Geebee Garments Industries Ltd. (11335)

DEPZ, Ganakbari, Savar
(+ 23.951528N, 90.271568E)

26.MAY.2014

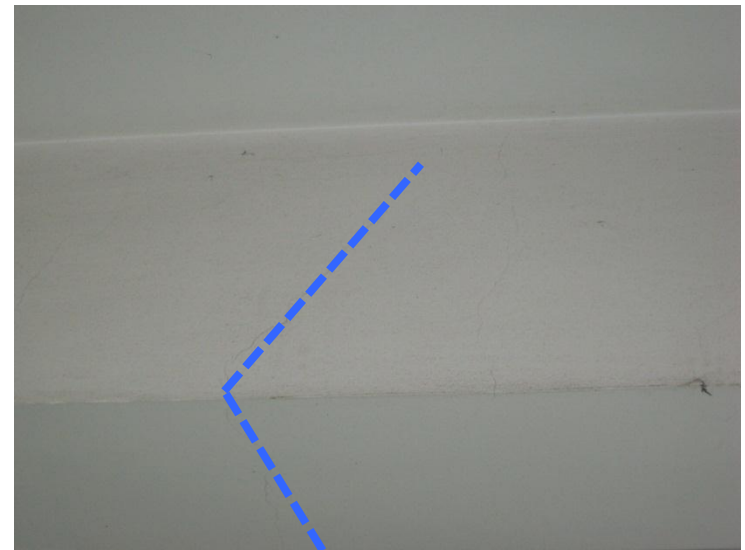
Cracks appeared underside beam on 1st, 2nd and 3rd floor. We require that these items be investigated in a Detail Engineering Assessment.

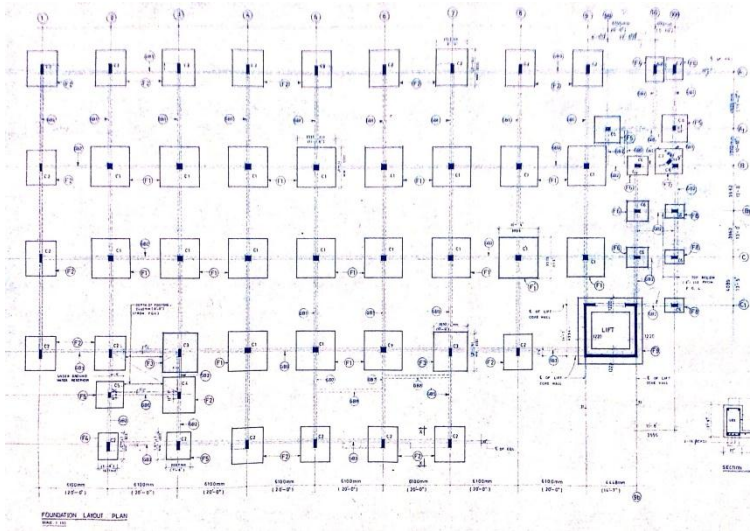
There are spalling of concrete and/or plaster found underside slab on 3rd floor slab. We require that these items be investigated in a Detail Engineering Assessment.
